ANN ARBOR HISTORIC DISTRICT COMMISSION

Staff Report

ADDRESS: 808 W Washington Street Application Number: HDC24-0188

APPLICATION: The applicant seeks HDC approval to rebuild a non-historic mudroom on the rear of the house in a footprint that is 24 square feet larger; construct a 23-foot-wide shed dormer on the south roof surface; and construct a 27'2" x 27'7" garage with a second floor accessory dwelling unit (ADU).

ALL LUMBER IN CONTACT WITH MASONRY OR STEEL TO NOT BE TREATED.

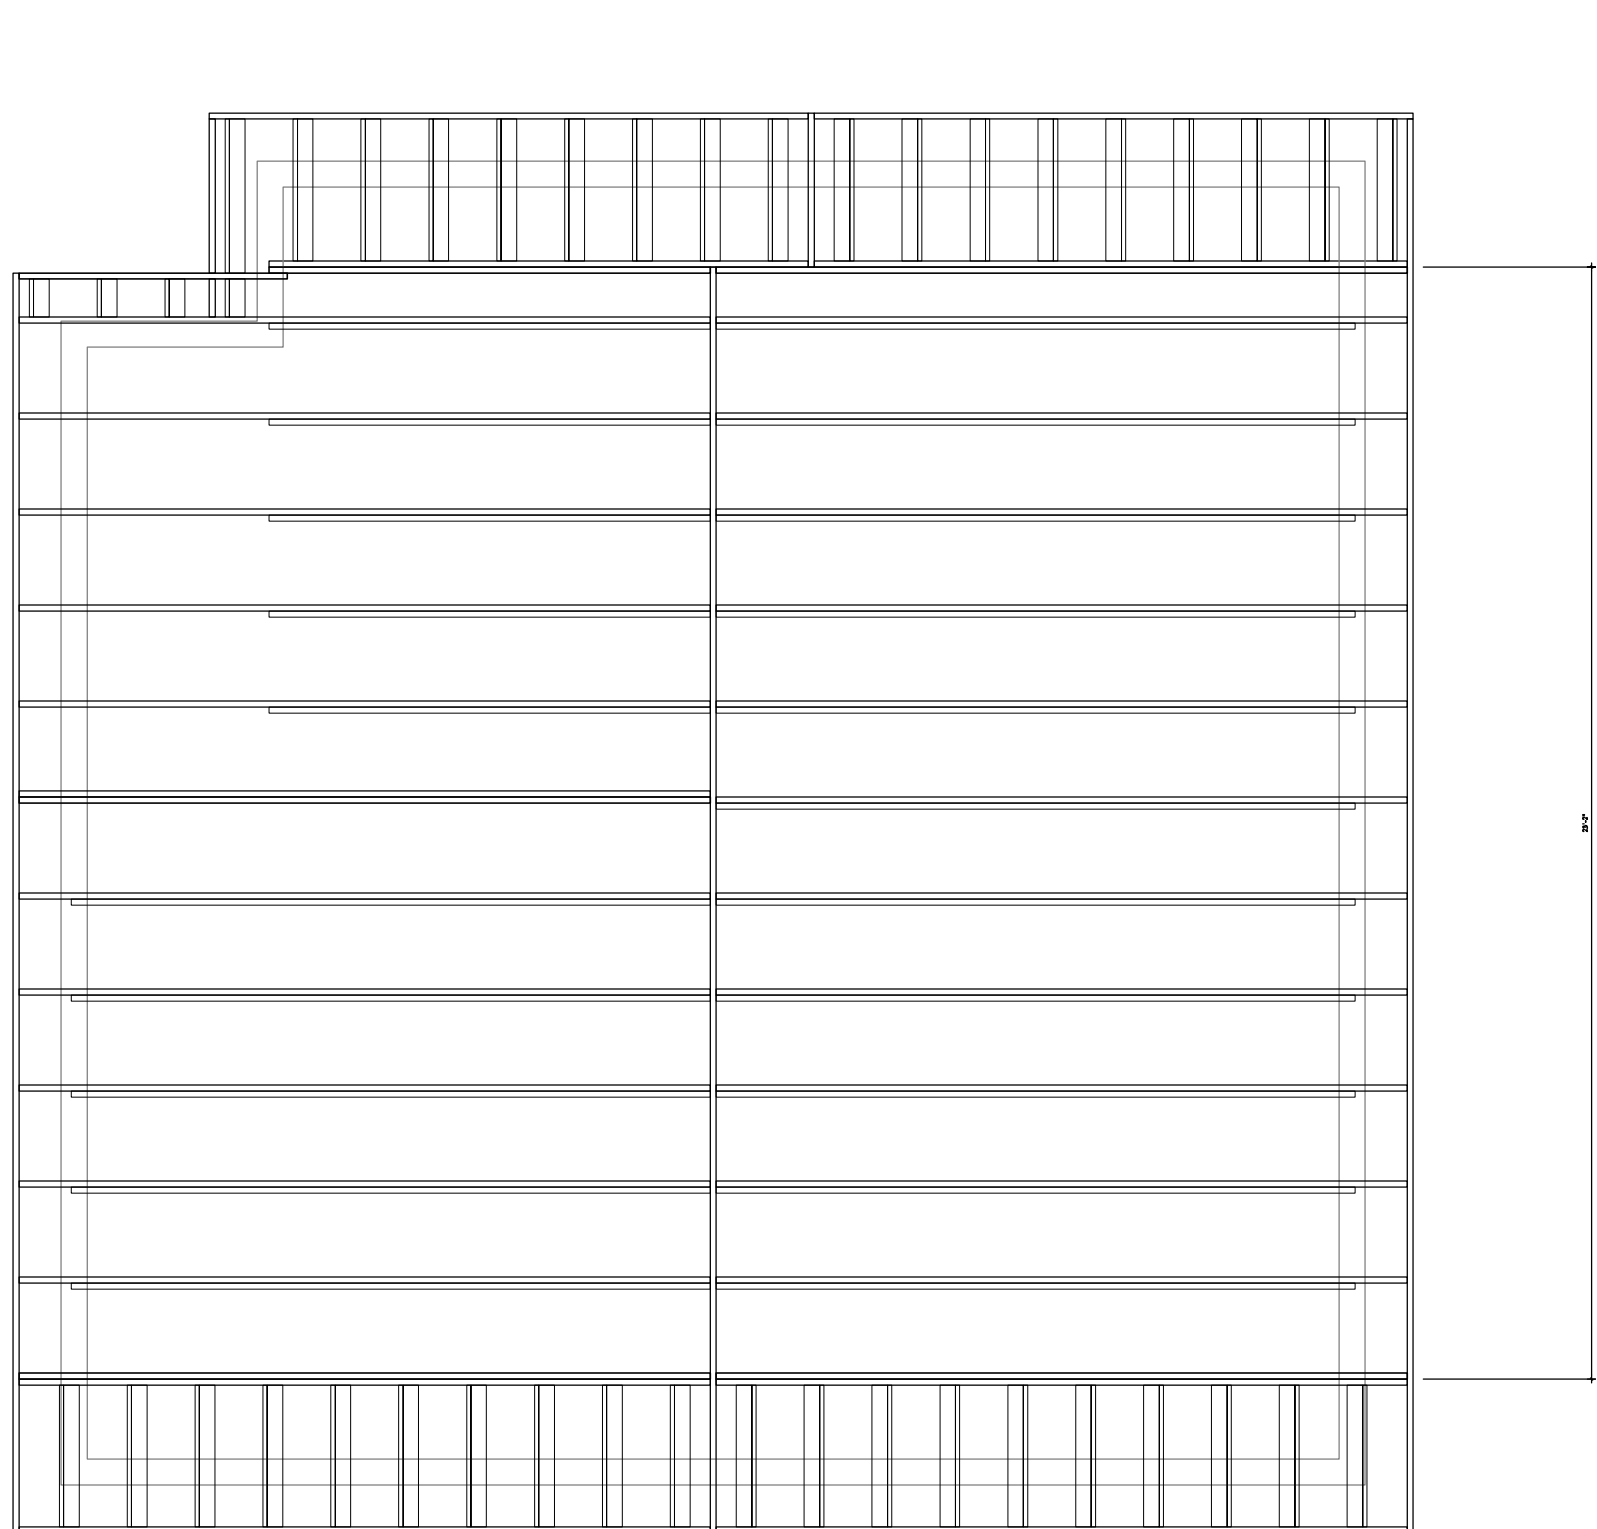
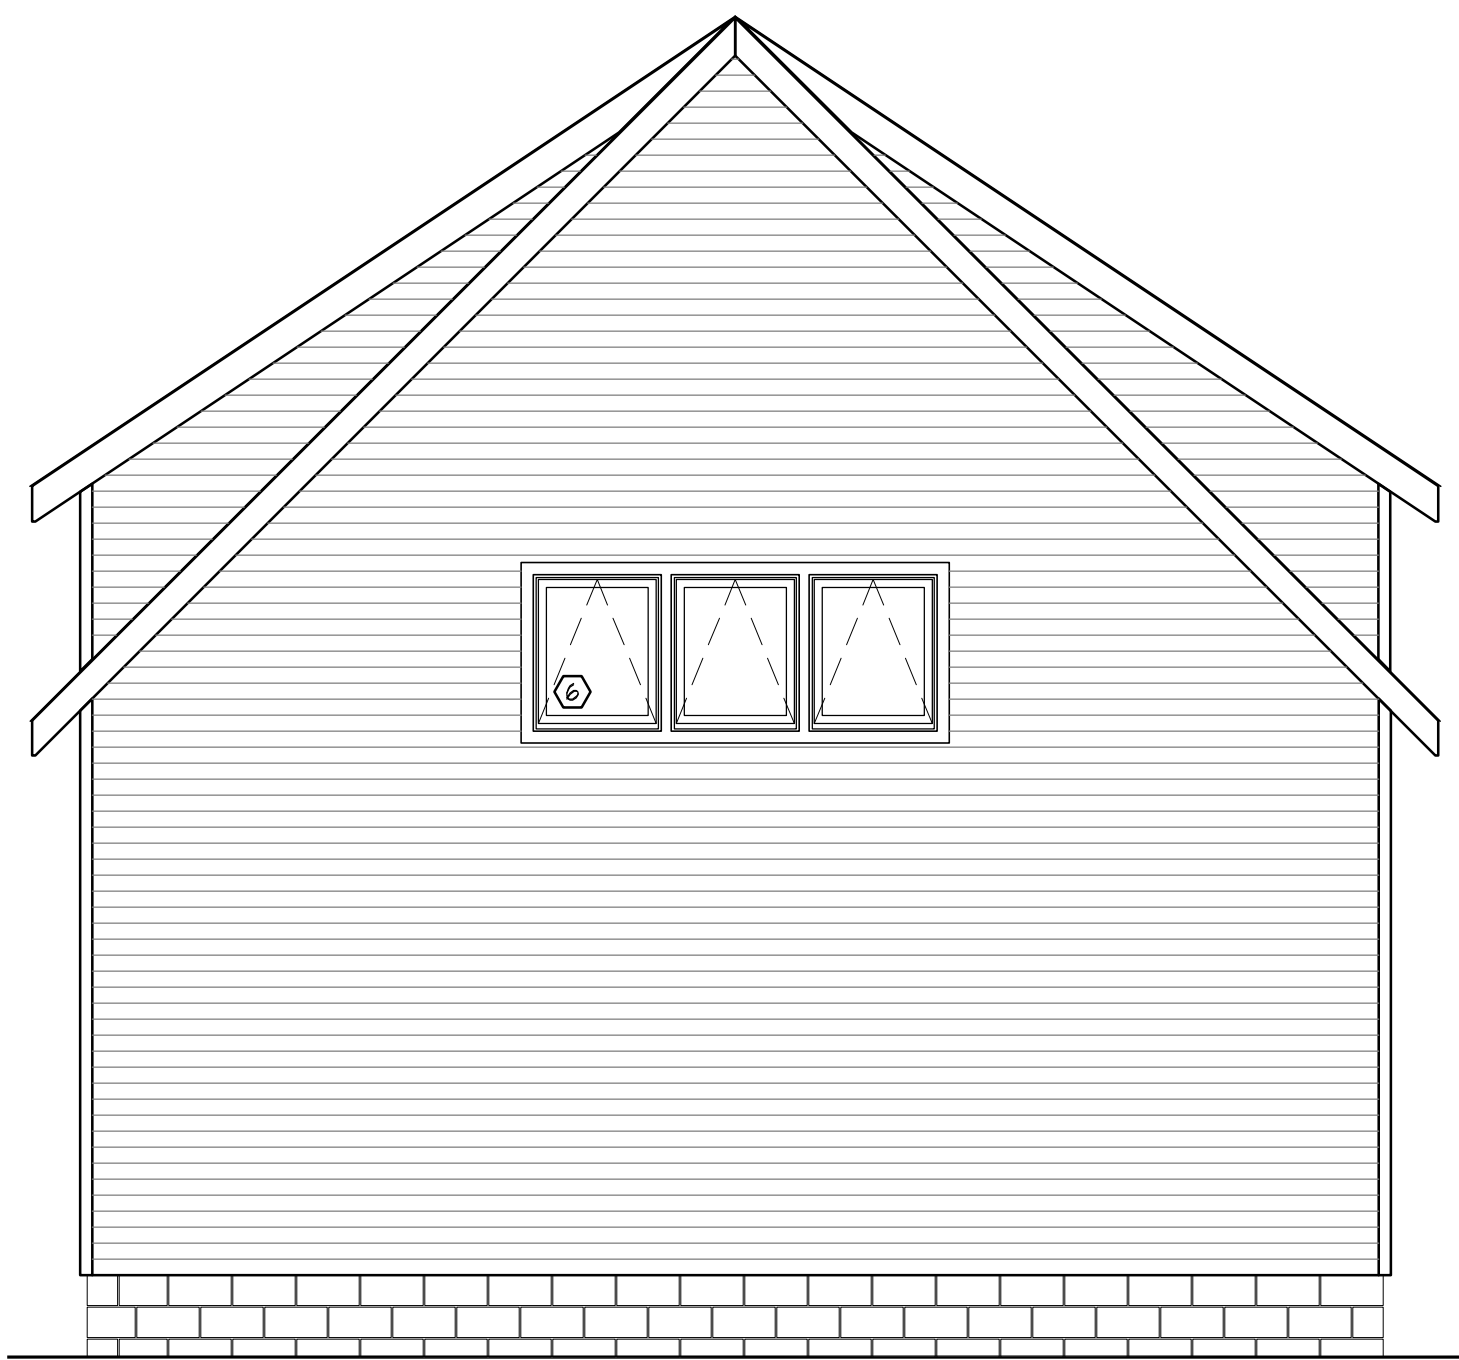
8. The garage has a 736 square foot footprint, with an accessory dwelling unit of the same size upstairs, for a total of 1472 square feet. This is very large for an accessory structure, though staff believes it is compatible with other garages and a large barn in the vicinity. The building is 1 3/4 stories with a ridge height of 26' 3". The zoning maximum height of 21' to the midpoint of the gable is not labeled, but this appears to comply. The foundation is slab on grade with concrete masonry unit trench footings. The garage has a two-car overhead door and a person door on the north elevation which accesses only stairs to the ADU. Materials for the overhead door and person door are not specified. This north elevation has two upper floor casement windows. The south elevation facing the house has a triple awning window and shed dormers on each side with single or paired
